GPO Box 1747 Brisbane QLD 4001 t 07 3166 9216 m 0417 607 242 www.qtraffic.com.au

Our Ref: 1746_HAL05

Reference: DEV2022/1300 Property Address: 57 Banana Street, Redland Bay Subject: Response to Further Issues – Traffic Matters

Figure 1 – Notional 3 Chord Truncation if Verge was 3.75m wide

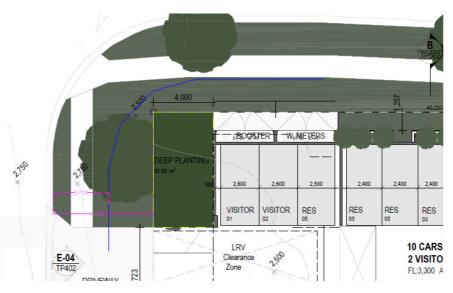
- a) Demonstrate sight line requirements can be met or provide corner lot truncations in accordance with Redland City Plan requirements.
- b) Demonstrate the headroom clearances in the basement are compliant with Australian standards. Provide cross-sections and dimensions on the plans/cross-sections to demonstrate this.

In response to item 1(a), it should be noted that the verge is very wide on Outridge Street measuring approximately 6.7m. This wide verge opens up the sightlines at the future intersection. This is best illustrated when a 3-chord truncation is superimposed over a 3.75m wide verge alignment. As shown in **Figure 1** below, this notional truncation (in blue) sits within the verge and as a consequence, further land dedication is not reasonably required.

Figure 3- Exiting Vehicles Swept Path

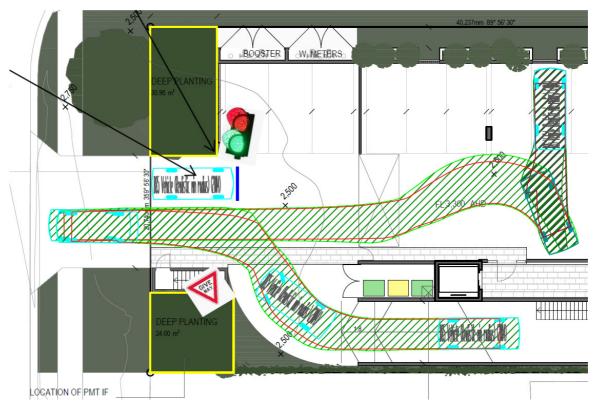
- i) Demonstrate how vehicles exiting the ground level carpark will exit safely. It is noted if the ground floor vehicles are exiting from the stop bay lane this will form a head-on conflict with vehicles entering /exiting or if exiting movements of ramp users are not restricted, possibility of two vehicles turning in the same direction simultaneously. Alternatively, if the ground floor vehicles are exiting from the ramp exit, there will be a conflict with the vehicles exiting using the ramp exit from the basement carparks.

In response to item 1(i), the plan has been amended such that the driveway aligns with the ground level carpark. This removes the possibility of any head-on as described by the State. The ramp to the basement is then offset to the aisle. The chance of a vehicle exiting from the basement at the same time a vehicle is exiting from the ground level carpark is very low. Notwithstanding this, the speeds are very low and a give way sign has been shown at the top of the ramp to ensure vehicles exiting from the basement give way vehicles exiting from the ground level.

Signal Management

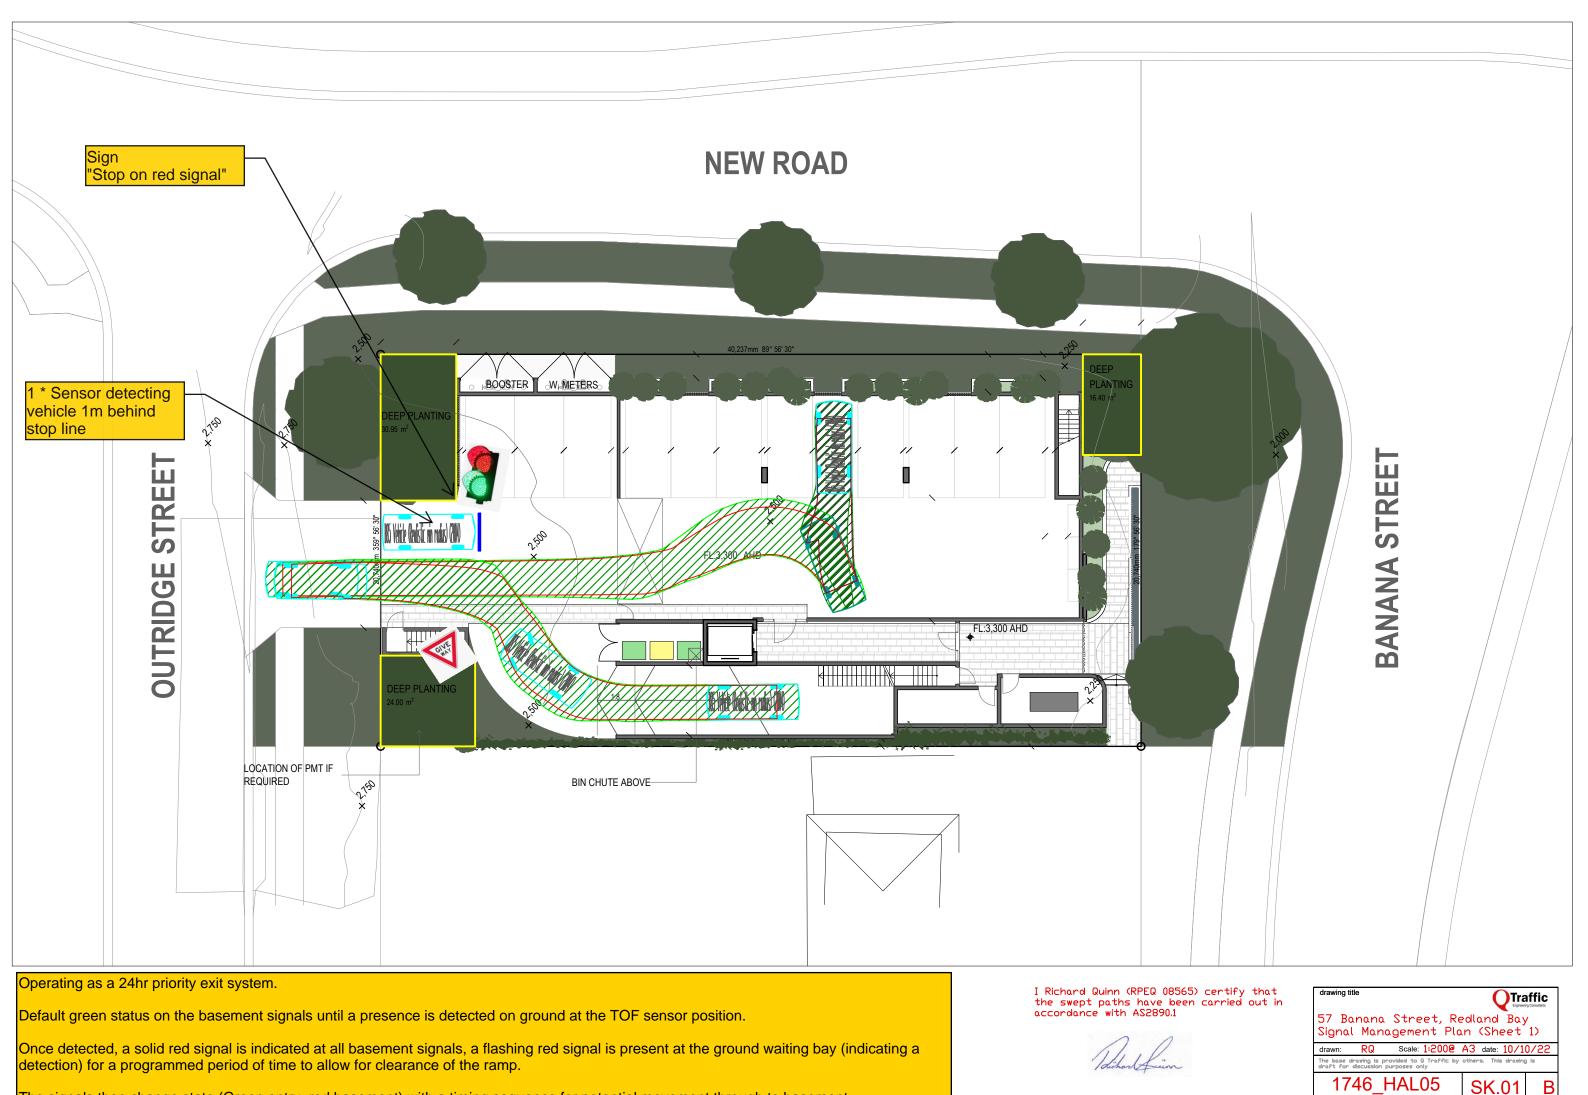
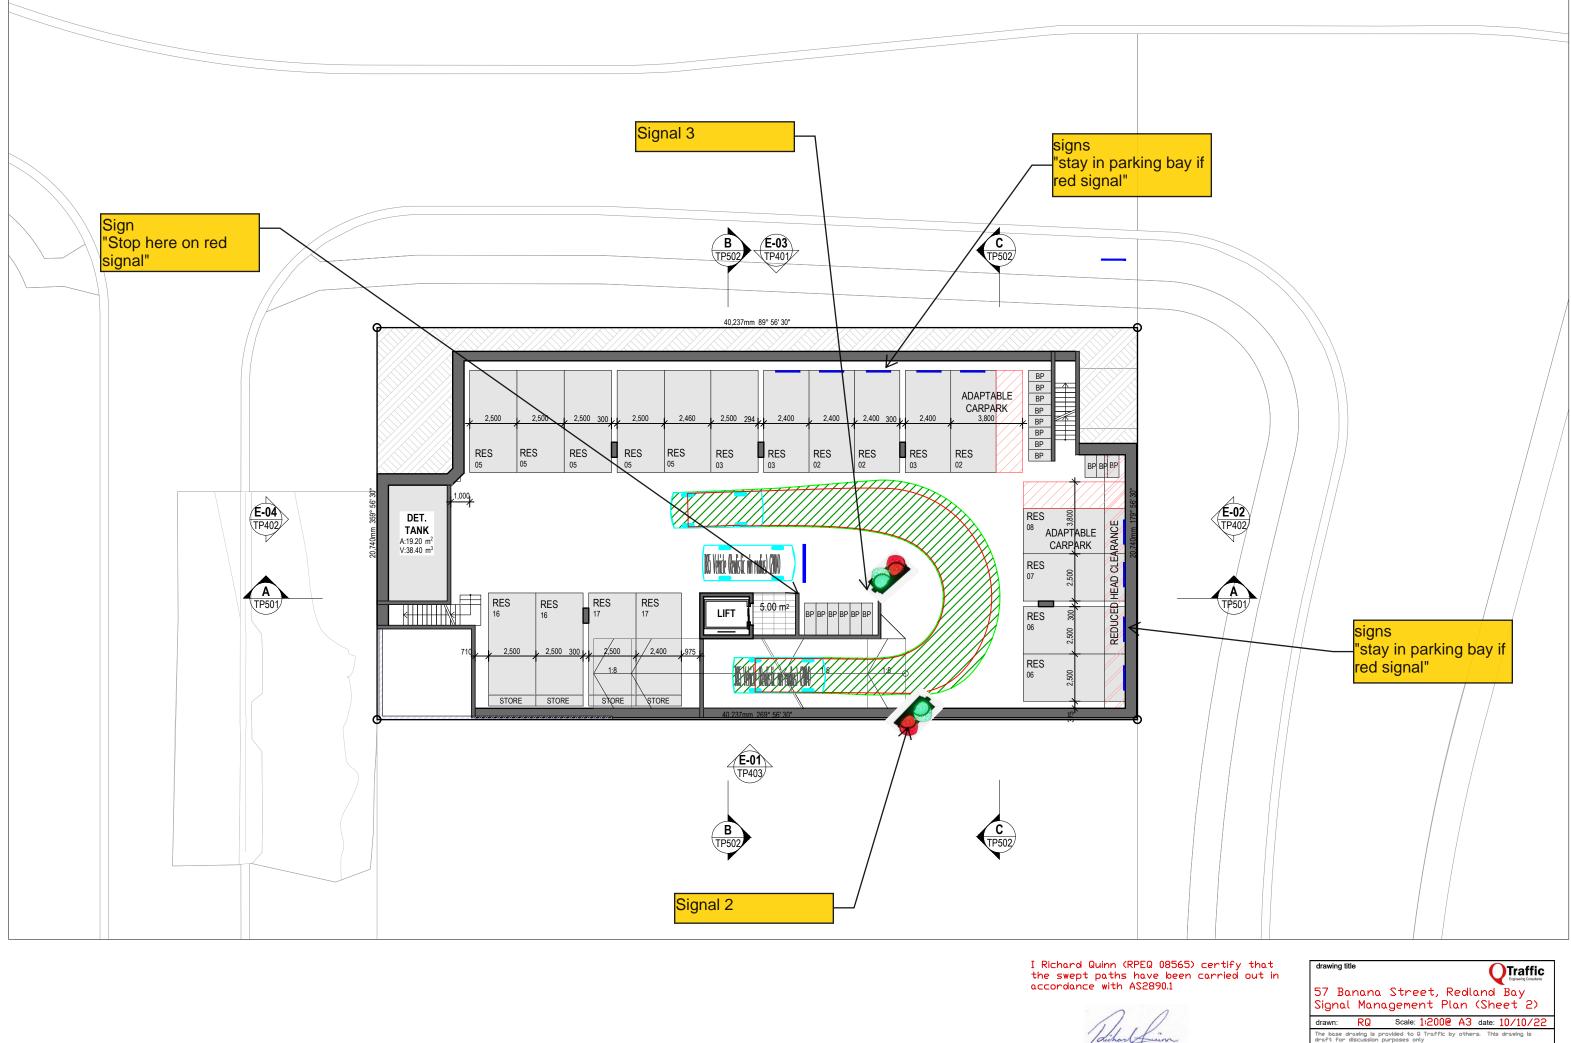
- e) Provide dimensions on plans to demonstrate that parking bays have the required clearances from walls.
- f) Clarify if a boom gate will be used at the entrance traffic lights.

In response to item 1(f) a boom gate is not proposed and is not required at the entry signal. The traffic control system has a stop line and traffic signal which informs entering vehicles of where to stop. This is standard practice for the management of two-way one-lane ramps within small residential car parks. Refer to the traffic management signal plan included as **Attachment 2**.
